Access Compliance Report

Public Rights-of-Way

(Curb Ramps)

Intersection ID: 42499	Main Street: ALEXANDER MARTIN AV	Cross Street: JAMES BLAKENEY AV	Location: SE
ADA ID: FB6D0904D1AE	Ramp Type: PerpDiag	Initial Pass/Fail: Fail	Overall Compliance: No
Severity Score: 25			
Codes/Mitigation Info/Possible Solution		Field Measurements/Component Compliance

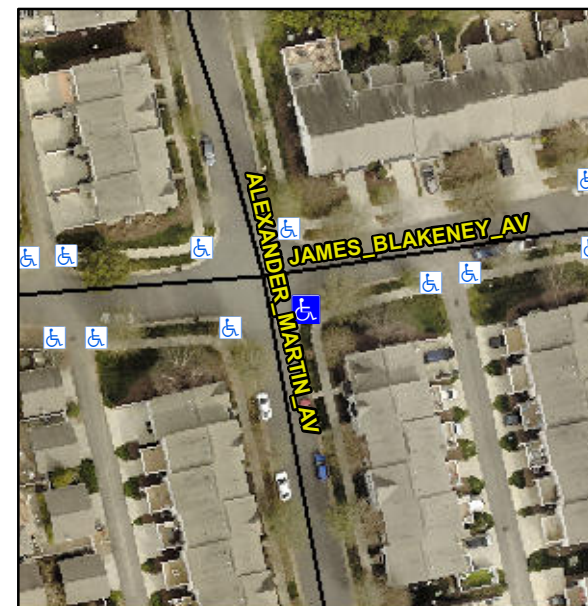
R304.2.2, R304.5.3

Compliance	Description	Data	Compliance	Description	Data
N/A	Ramp Length (in)	70.5	No	Ramp Slope (%)	10.8
Yes	Ramp Width (in)	98.0	No	Ramp XSlope (%)	5.2
N/A	Flare Type LT	N/A	N/A	Flare Type RT	N/A
N/A	Flare Slope LT (%)	N/A	N/A	Flare Slope RT (%)	N/A
N/A	Flare Traversable LT?	N/A	N/A	Flare Traversable RT?	N/A
N/A	Landing Length (in)	N/A	N/A	DWS Provided?	N/A
N/A	Landing Width (in)	N/A	N/A	DWS Contrast?	N/A
N/A	Landing Slope (%)	N/A	N/A	DWS Length (in)	N/A
N/A	Landing X Slope (%)	N/A	N/A	DWS Full Width?	N/A
N/A	Landing Curb? (Y/N)	N/A	N/A	DWS Offset (in)	N/A
N/A	Shared Landing?	N/A			
N/A	Gutter Ponding?	N/A	N/A	Gutter Slope (%)	N/A
N/A	Gutter Lip Ht (in)	N/A	N/A	Gutter X Slope (%)	N/A
N/A	Painted X Walk1?	No	N/A	Painted X Walk2?	No
	X Walk 1 Direction	To N		X Walk 2 Direction	To W
N/A	X Walk 1 Width (in)	N/A	N/A	X Walk 2 Width (in)	N/A
	X Walk 1 Slope (%)	1.3		X Walk 2 Slope (%)	3.8
	X Walk 1 X Slope (%)	4.3		X Walk 2 X Slope (%)	2.3

N/A	Ramp inside XWalk1?	N/A	N/A	Ramp inside XWalk2?	N/A
	Road Slope (%)	3.7	N/A	Clear Space?	N/A
	Road X Slope (%)	2.4	N/A	Clear Space to XWalk (in)	N/A
N/A	Any Obstructions?	N/A	N/A	Storm Grate/Utility Hazard?	N/A
	Obstruction Type			Storm Grate/Utility Type	
		N/A			N/A
			Yes	Surface Condition? (G/P)	Good

Remove & Replace Curb Ramp With Two New Directional Ramps or Equivalent.
